## Reply to the comments:

Reviewer #1, Dr. S. D. Rosen:

Figure 1: Land subsidence in Asian megacities

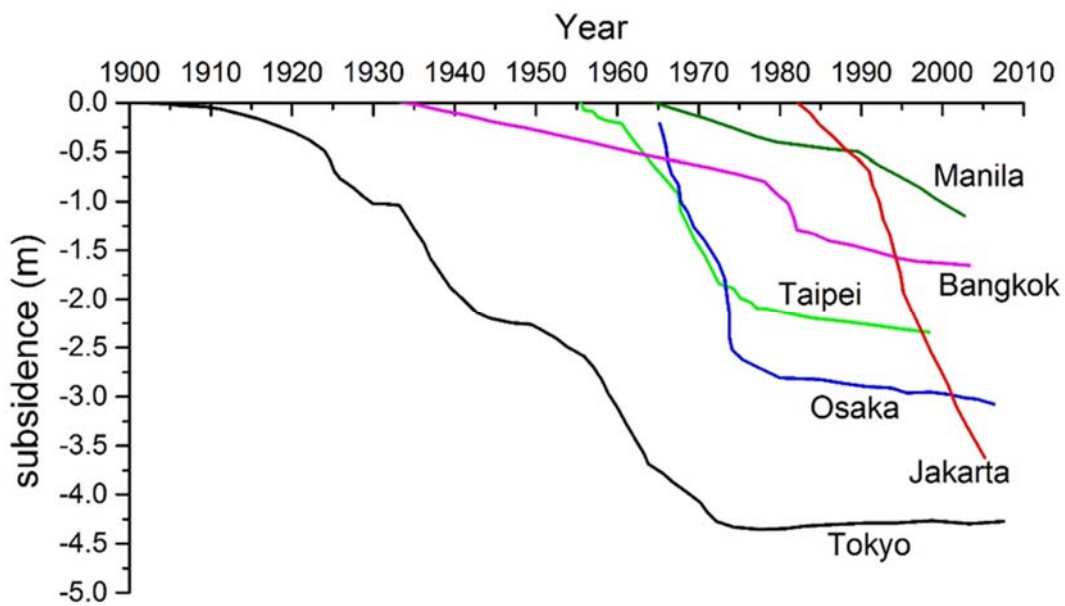
3. A fast and significant subsidence rate has been indicated for the recent past years. It is not clear on what basis the same rate is maintained for the coming 10 years as well as for further time states. The subsidence would depend on the soil type of the underground and the thickness of the pervious layers, so it is not necessary correct to extrapolate the same sinking rate for the

future, unless the pervious soil and its thickness give base to this assumption, fact that is not stated.

As the reviewer suggests, the land subsidence appears to be the most difficult issue in projecting floods in a rapidly developing coast such as Jakarta. Since publicly available data is very limited in the country, it may not be easy to project the subsidence rate by a theoretical method (*e.g.* Terzaghi consolidation theory). Thus, we simply assumed that land subsidence will continue at the present rate for a while (at least 10-15 years), resulting in a 2-meter subsidence in the studied area, based on the subsidence rate over the last couple of year shown in Fig.1 and other published articles on subsidence in Jakarta. We consider this projection does not really overestimate things, given the recent rate continues unabated at present.
